I PROJECT:	Wynot Public School Addition & Renovation	PROJECT NO.	L14208
FROM:	BVH Architects	DATE:	17 March 2016
TO:	All Bidders	ADDENDUM NO.	1

Wynot Public School Addition and Renovation
R.O. Youker, Inc. Project #16005
Addendum 1 Items
3/17/2016

addendum no. 1

WALL SECTIONS

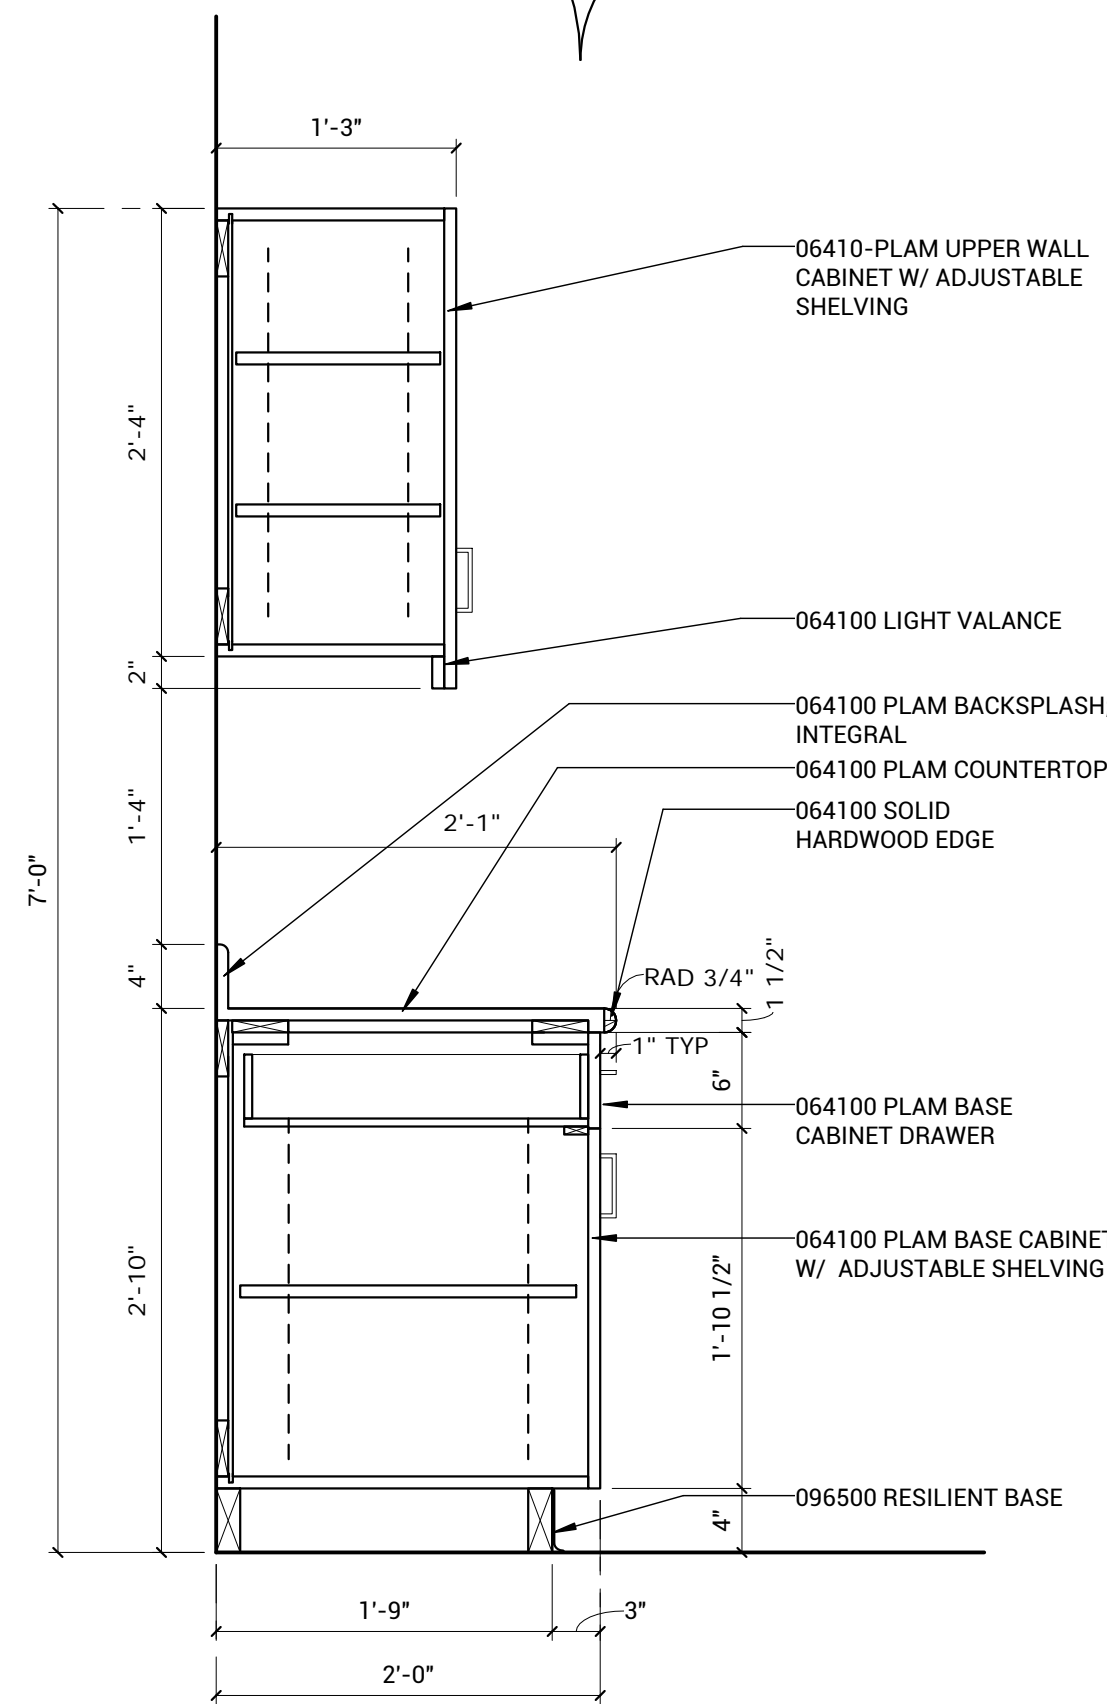
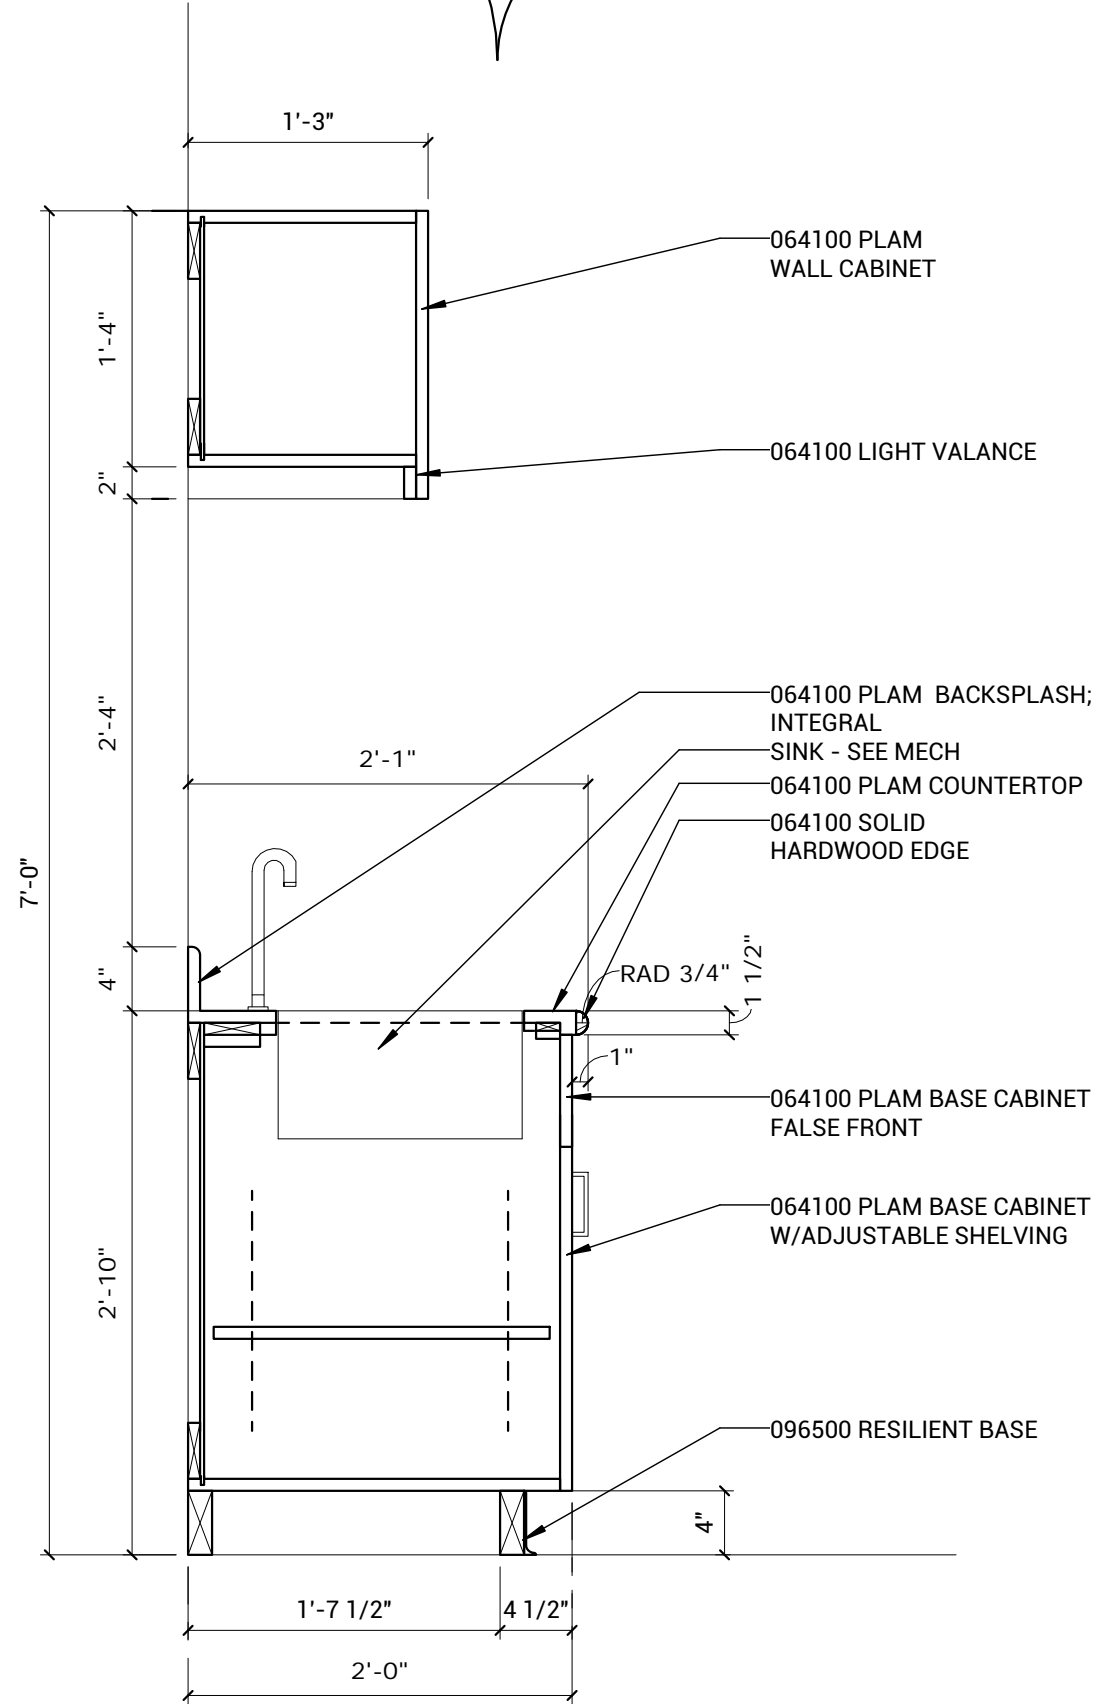
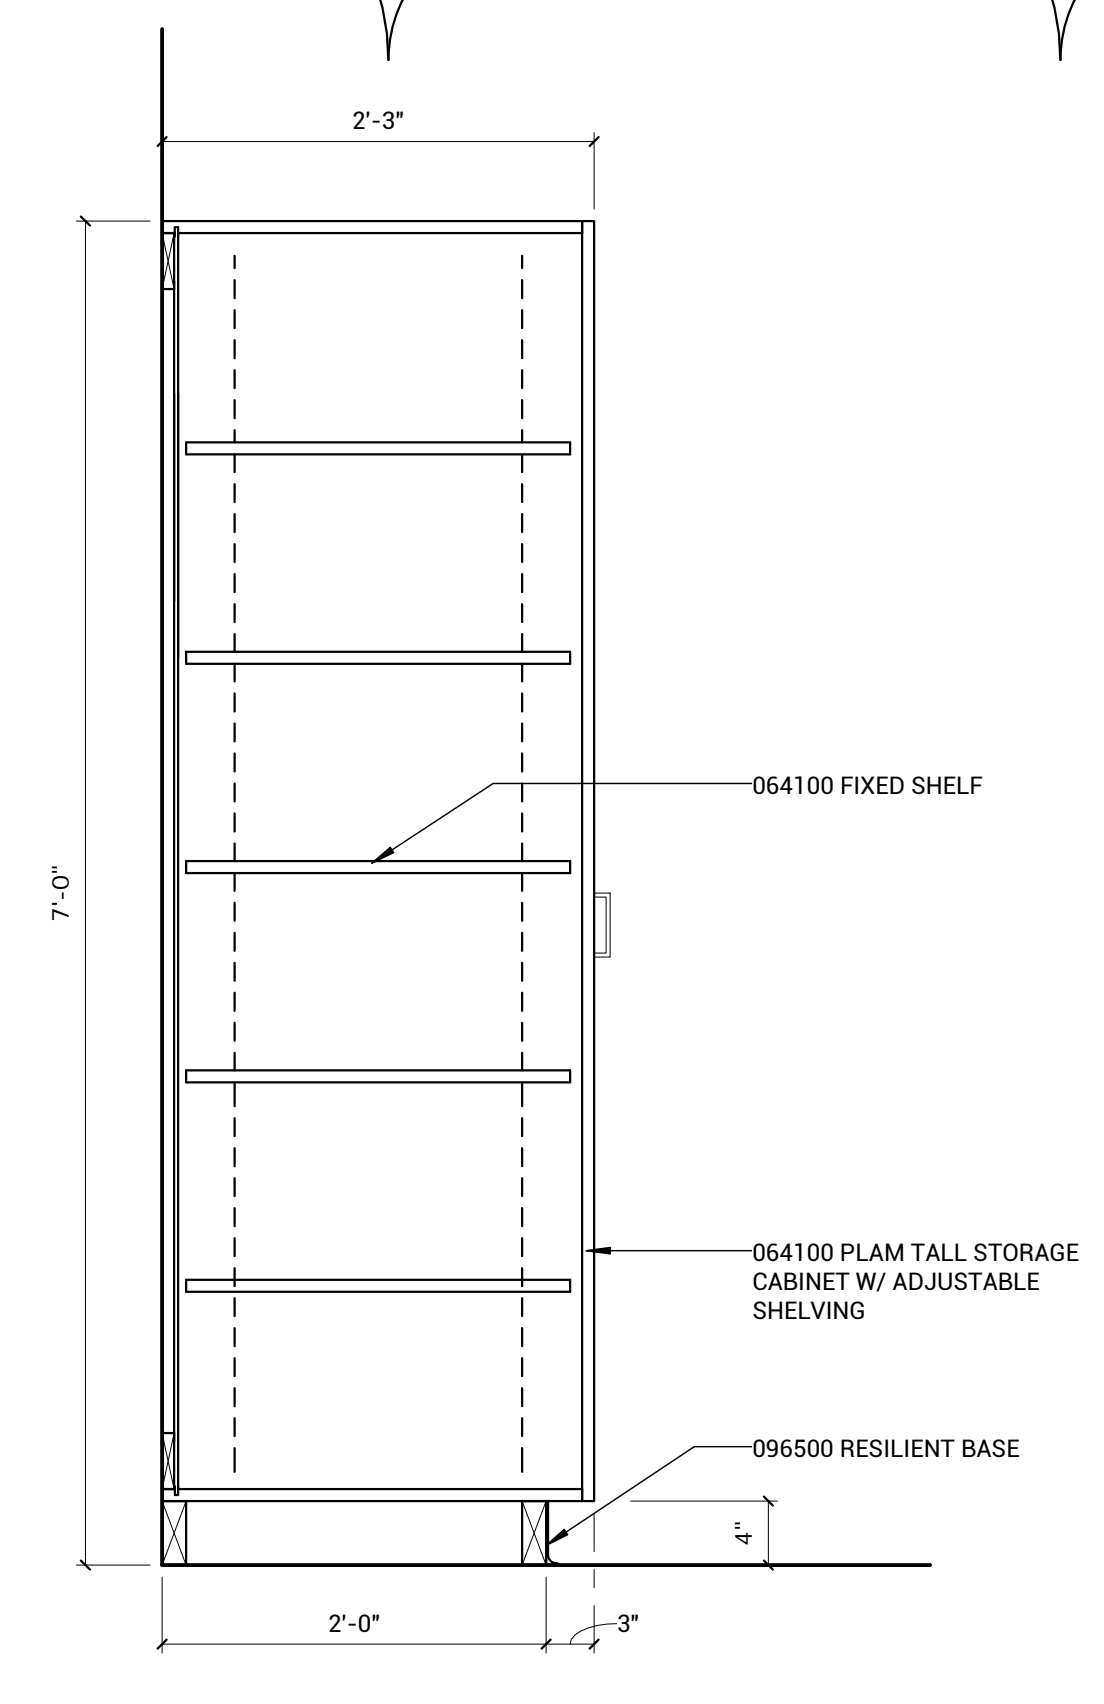
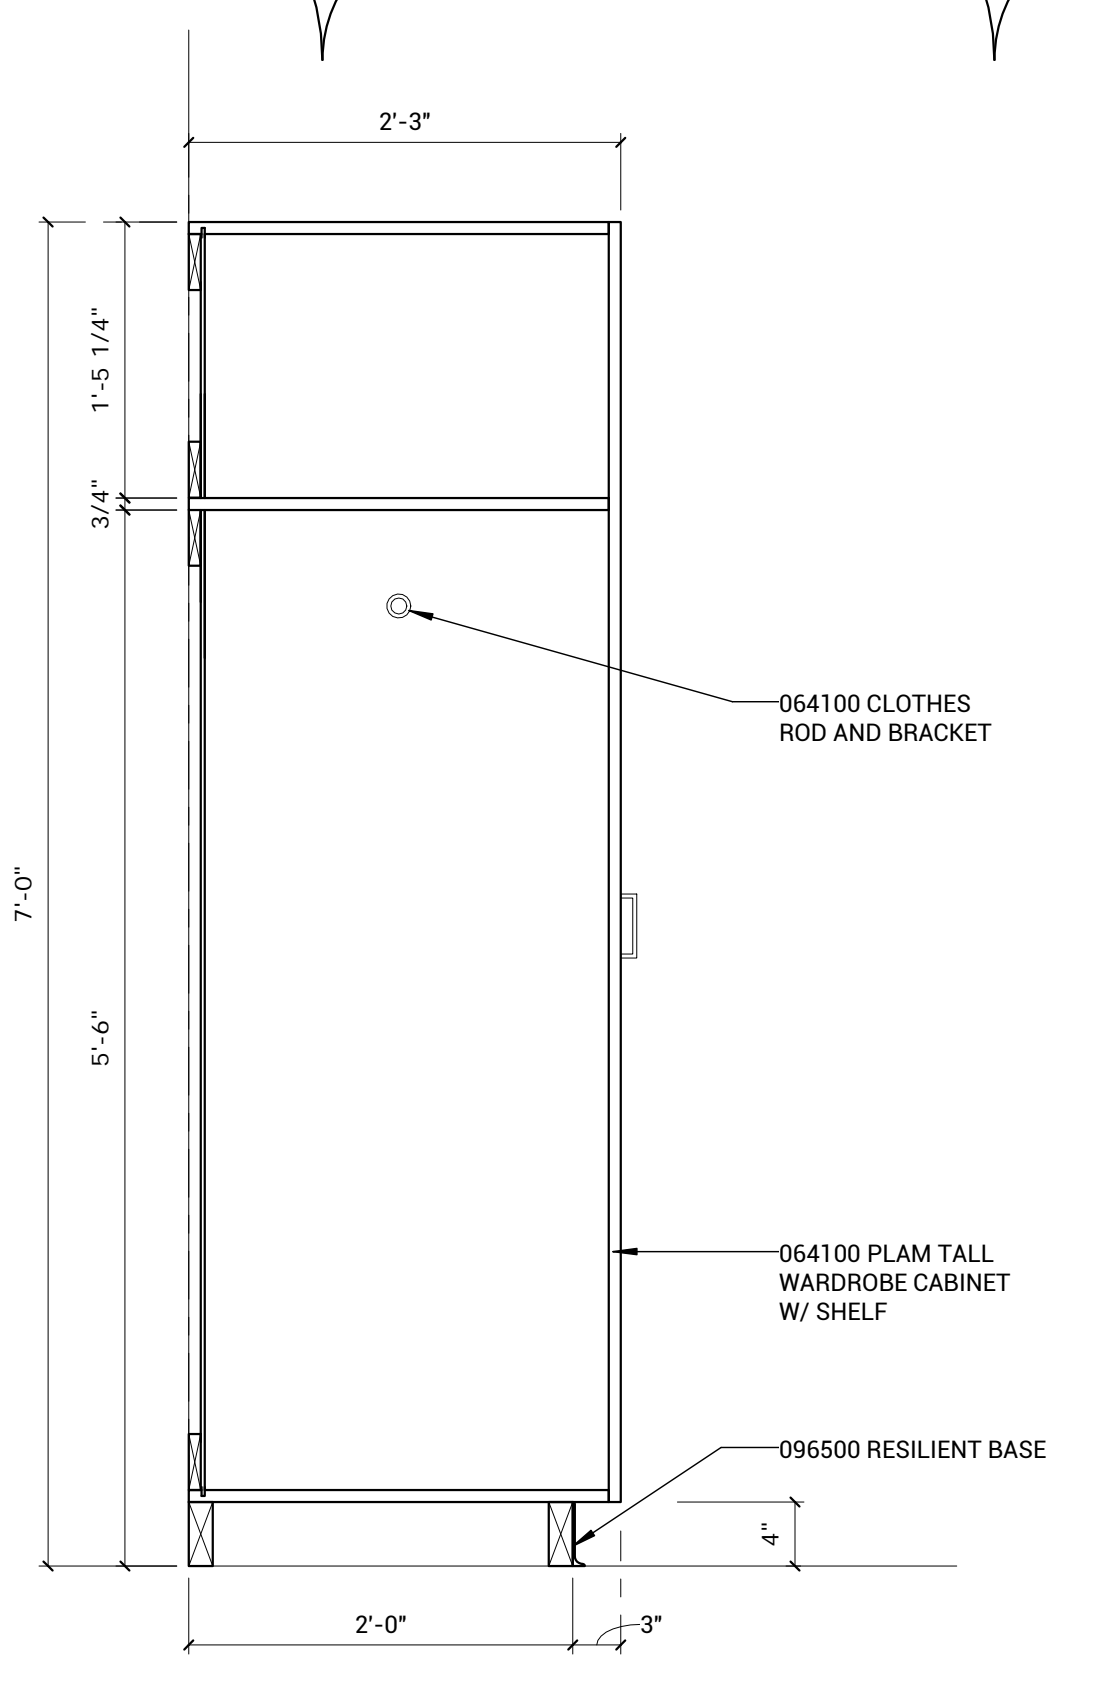
- b. Detail B13 (refer to attached Drawing 1)
 1. Window head and parapet revisions.
5. Sheet A5.3 Wall Sections (refer to re-issued sheet A5.3)
 - a. Typical casework sections added.
